13 May 2024

Mareeba Shire Council
65 Rankin Street
PO Box 154
Mareeba QLD 4880

**Response to Pre-Request for Information
2-4 Quill Street, Mareeba (OPW/21/0006)**

PROJECT REF	CONMAT PTY LTD		
	QUILL STREET LAND DEVELOPMENT		
DRAWING REF	CLEARING PLAN		
DRAWING NO	160-001-C102	SIZE	A3
		REVISION	B

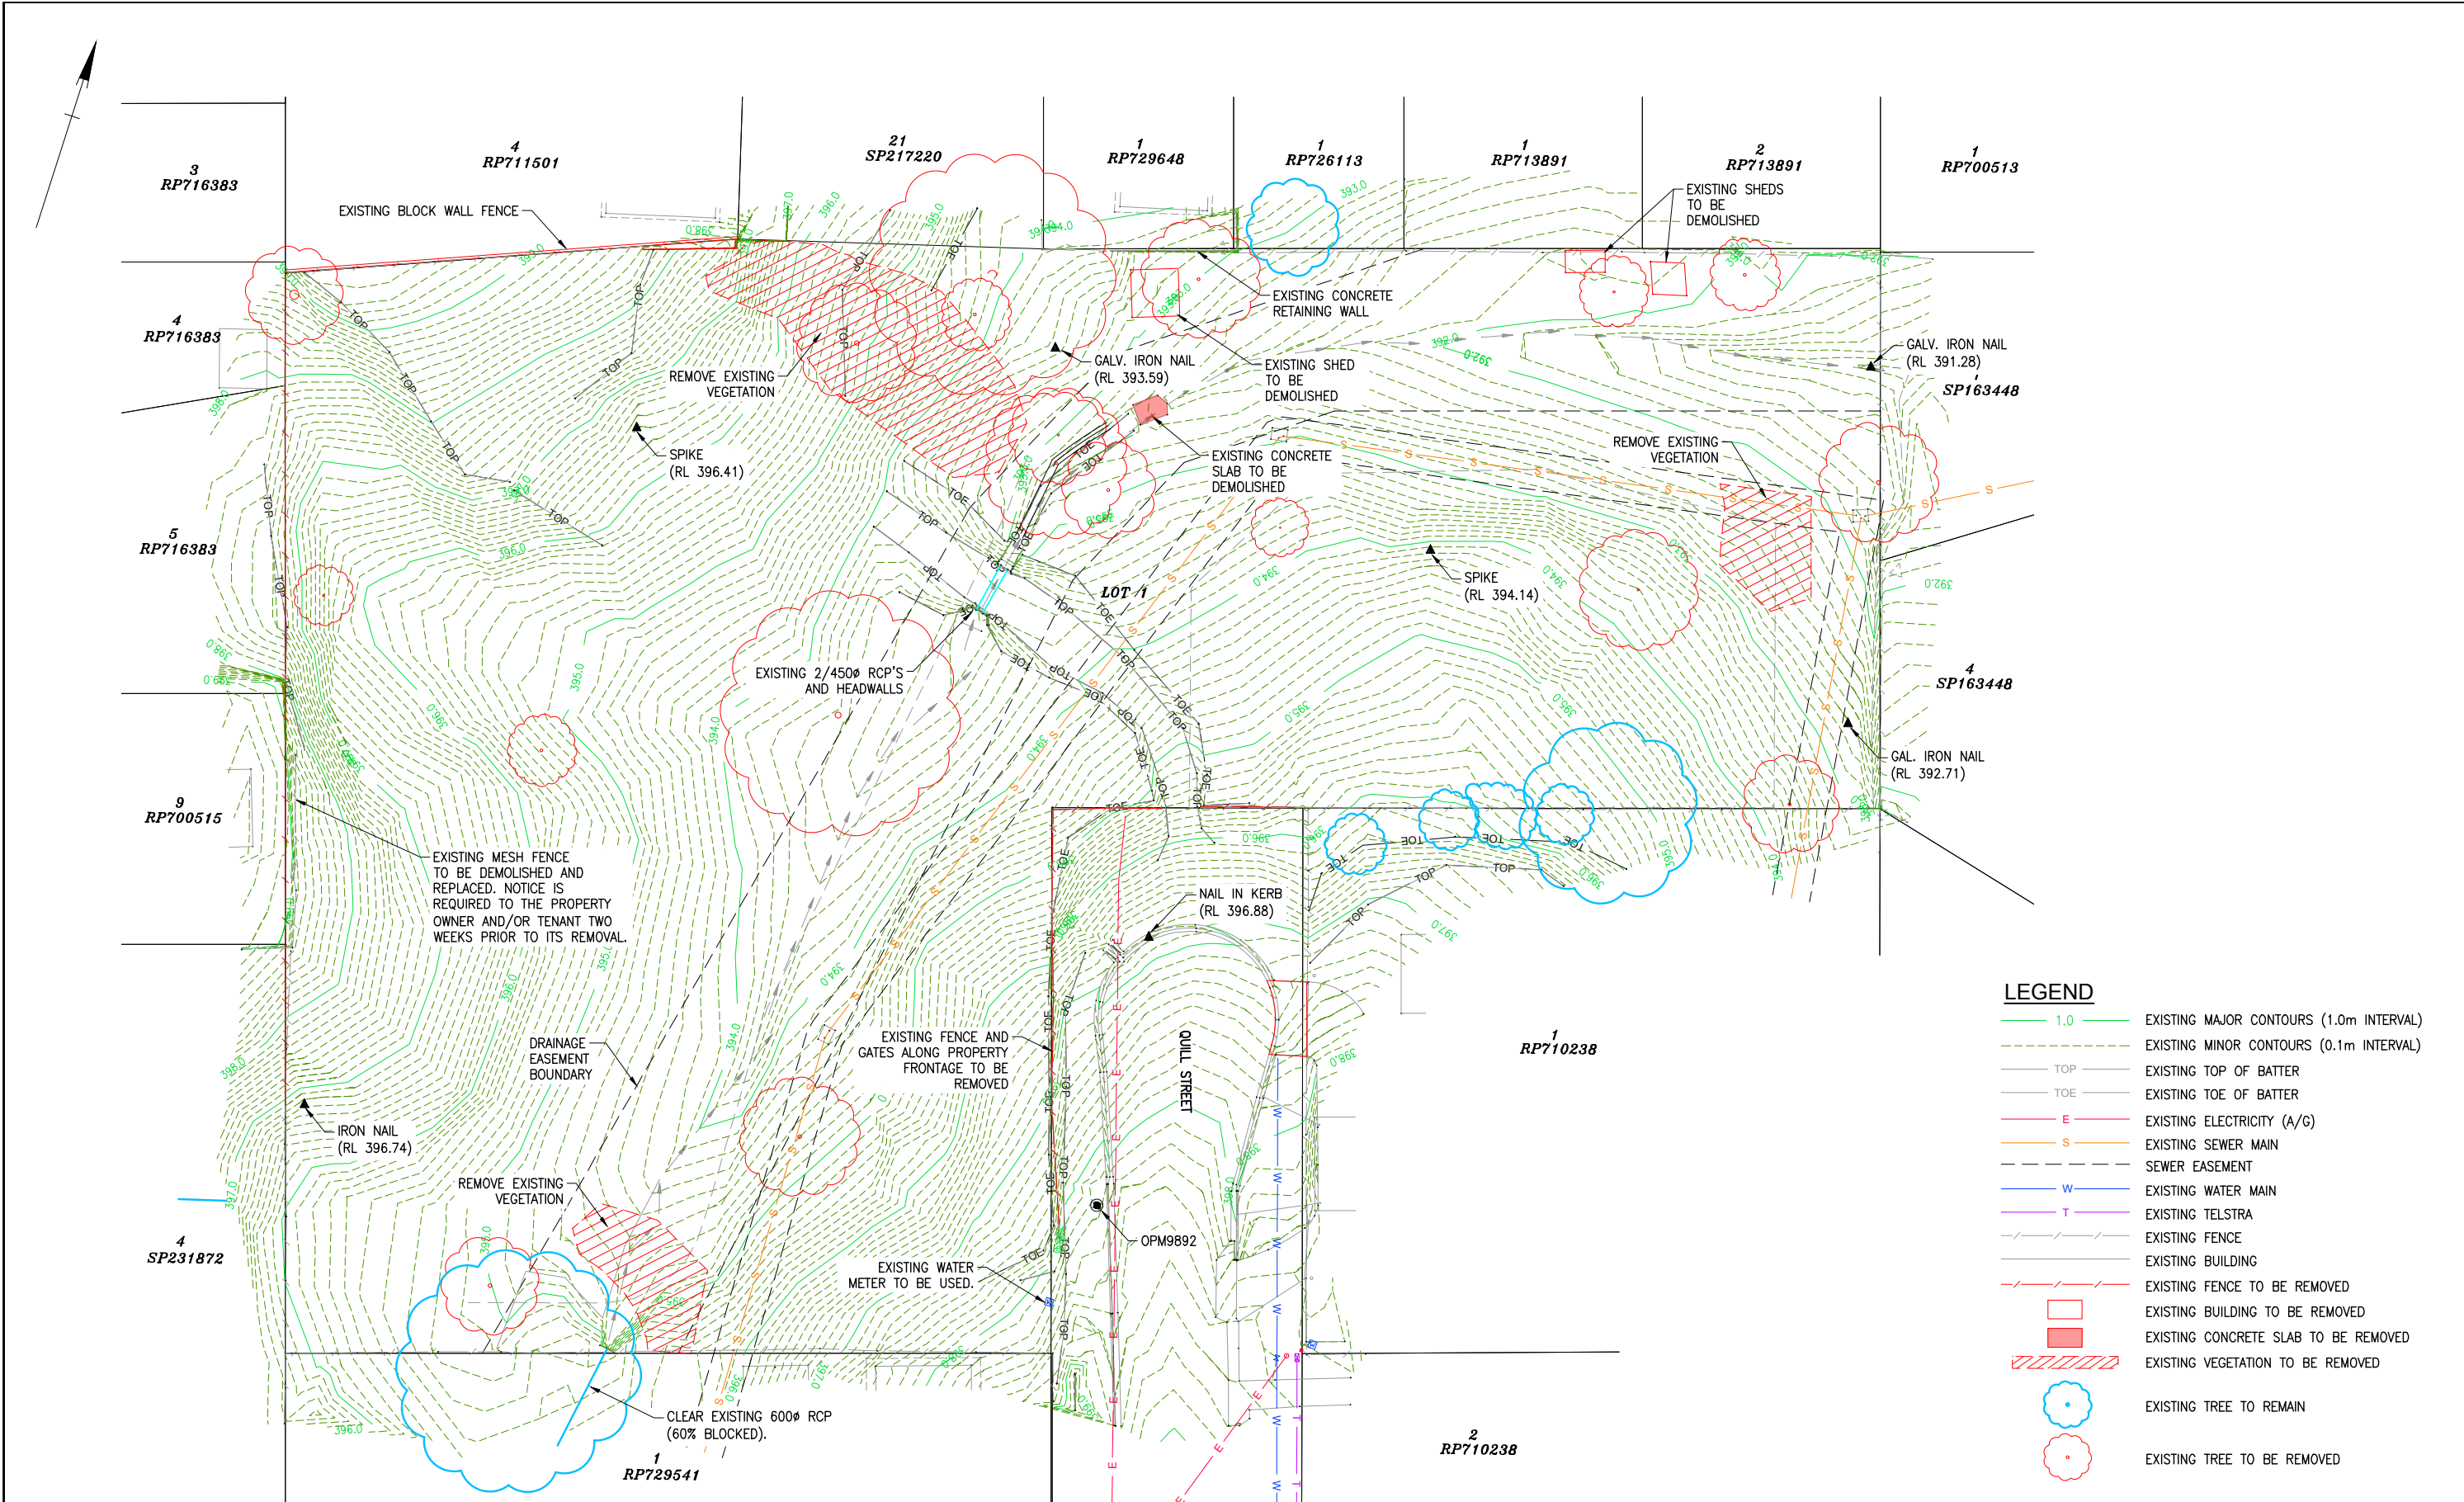
3. The note(s) on the demolition plan regarding removing fences must be amended to include wording requiring a minimum of two (2) weeks' notice to the property owner and tenant (if applicable) prior to the removal of fences.

The notes must specify that temporary exclusion fencing is to be provided to ensure no unauthorised access to the worksite.

The standard of the replacement fence must be agreed between the parties. The agreement between the parties is to be forwarded to Council prior to the works commencing on this element.

Please see amended drawing 160-001-C102-Rev B which shows the amended note indicating two weeks notice to be given to the property owner and tenant.

PROJECT REF	CONMAT PTY LTD		
	QUILL STREET LAND DEVELOPMENT		
DRAWING REF	DRIVEWAY PLAN		
DRAWING NO	160-001-C105	SIZE	A3
		REVISION	B

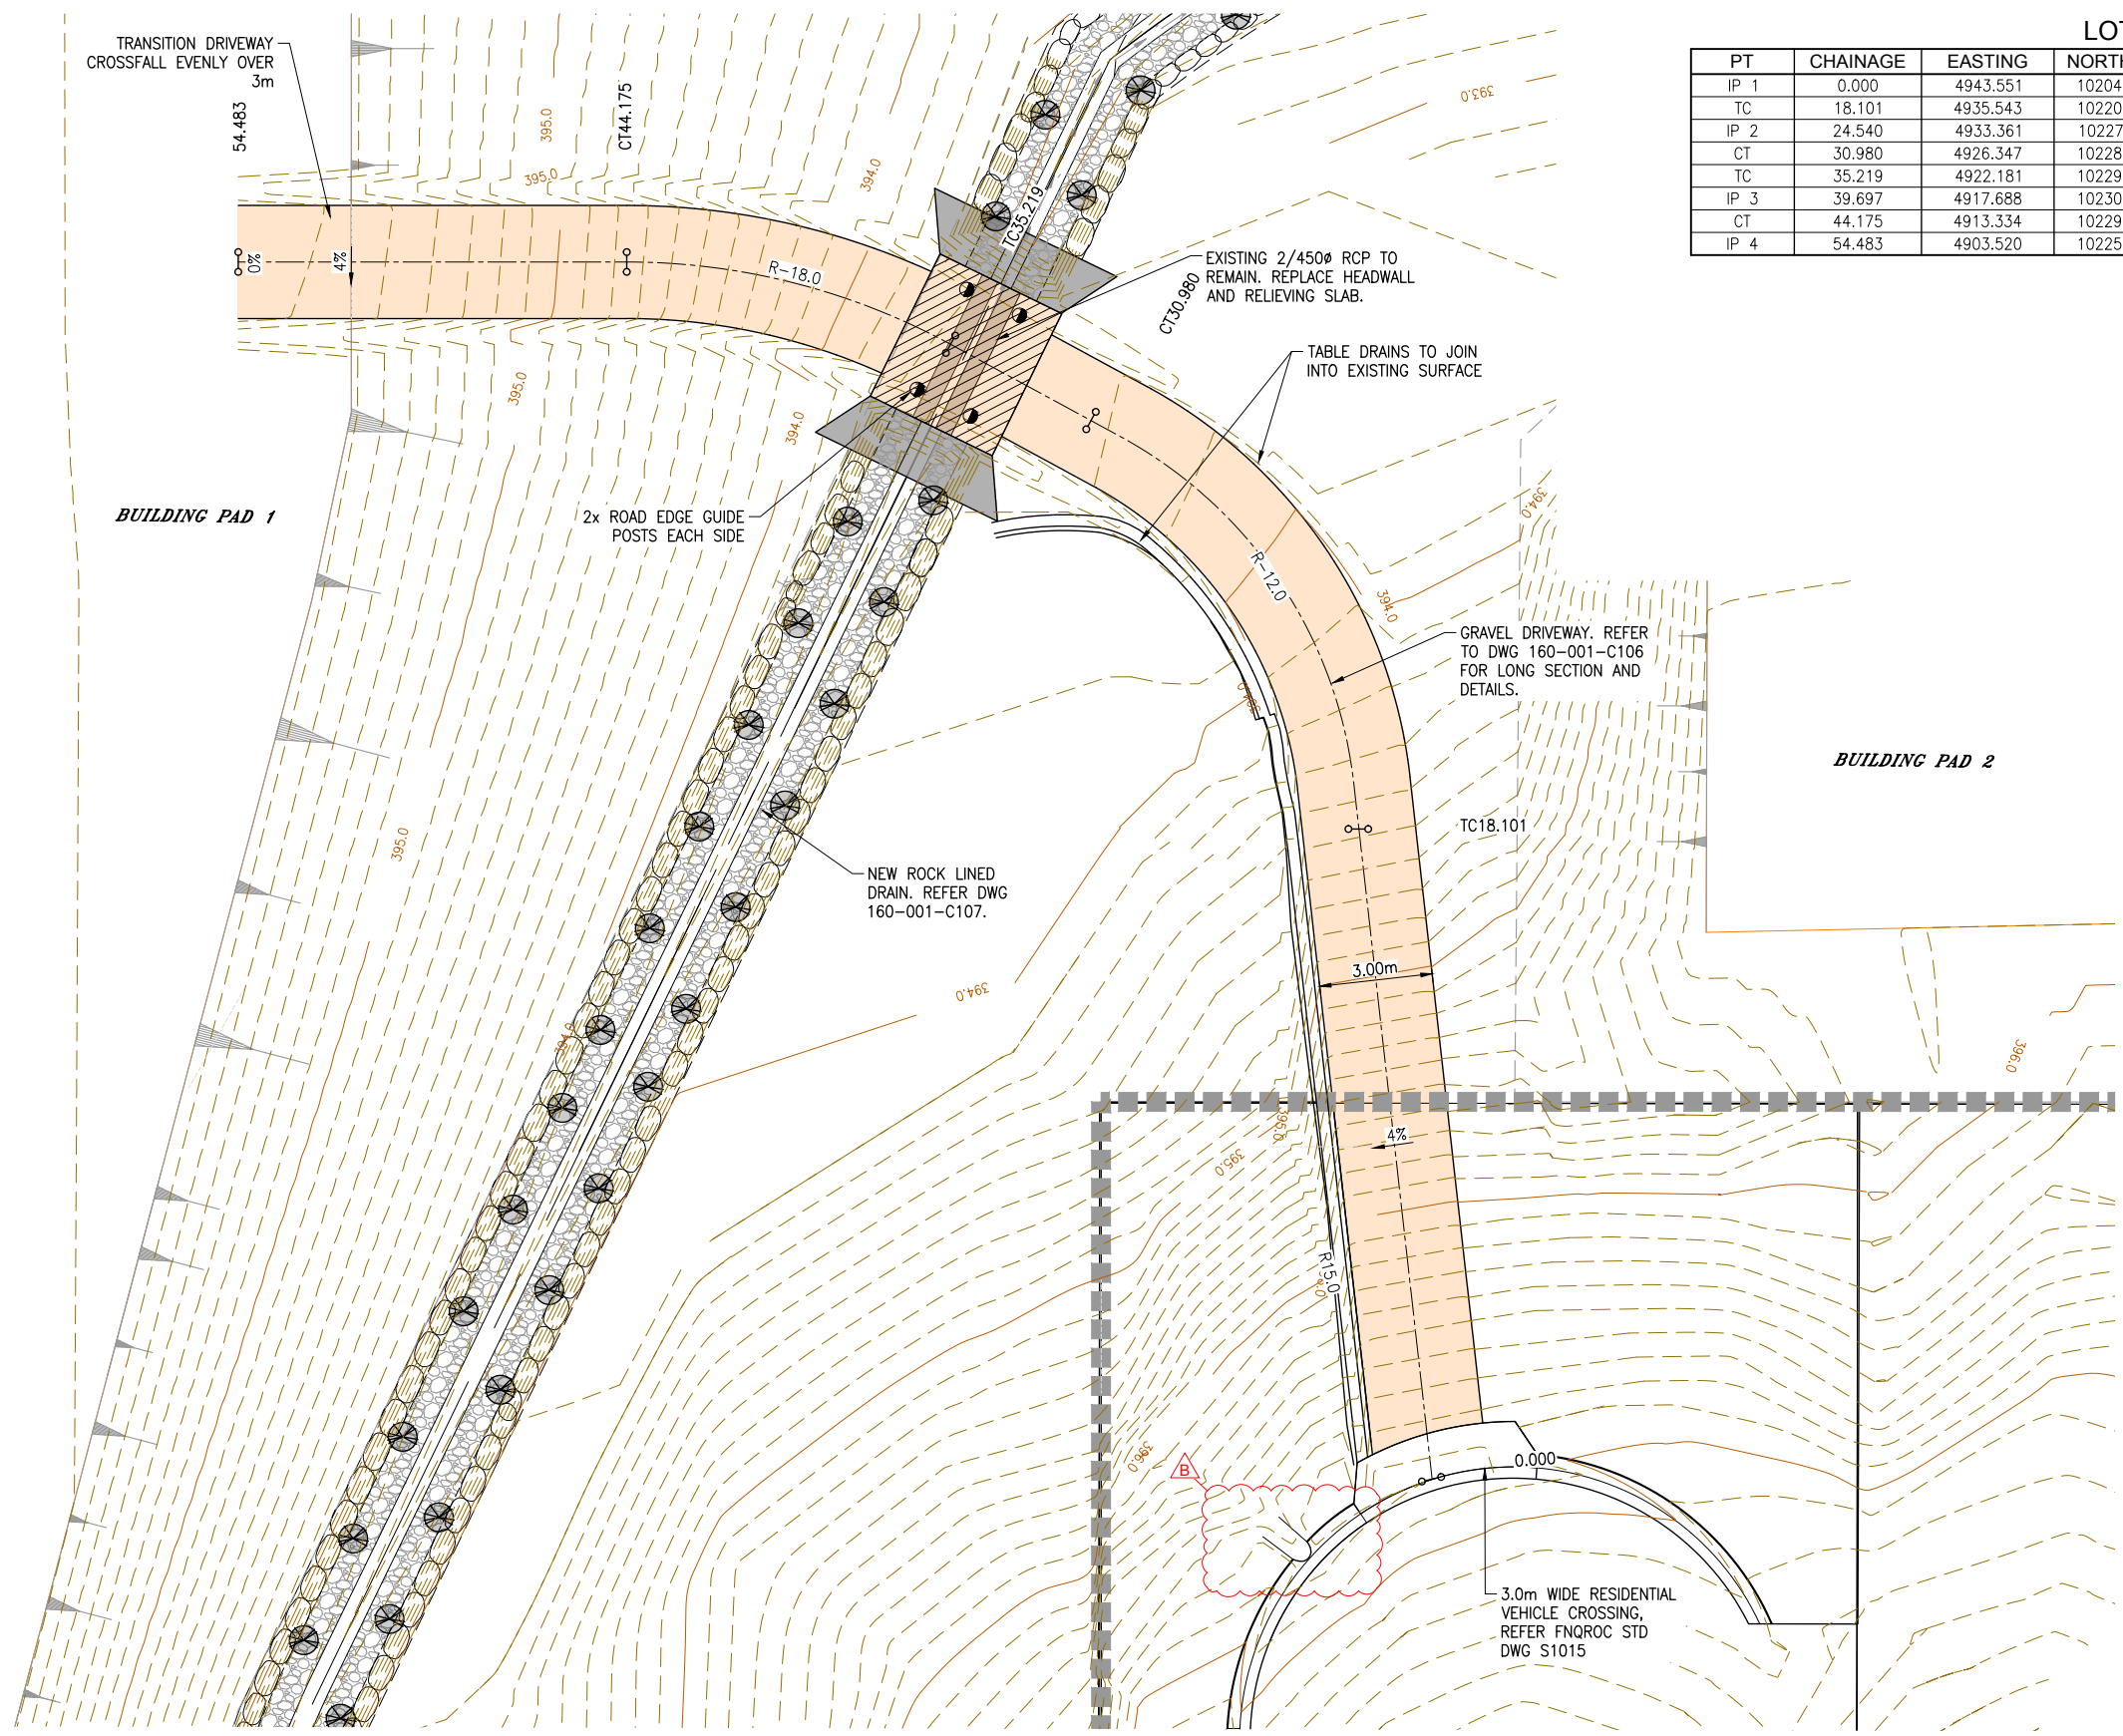
1. For the works proposed within the Quill Street road reserve, provide the following information:
 - a. Clarify the linework included on the drawings for works at the end of Quill Street. The linework appears to include a kerb inlet pit, additional driveway crossover to the west and a section of concrete behind the kerb. [Plan work will be supplied at the RFI, further detailing the crossover kerb and driveway. The indicated kerb inlet pit at the Quill Street Cul-de-sac head will be removed from the plan and replaced with a kerb outlet to an overland flow, which represents the existing conditions. Please see amended drawing 160-001-C105-Rev B.](#)

- b. Provide amended drawings showing the existing and finished surface contours at 100 mm intervals to enable an assessment of the finished surface proposed at the Quill Street cul-de-sac and the driveway segment within the road reserve. [Please see amended drawing 160-001-C105-Rev B which shows the existing and design contours at 100mm intervals.](#)
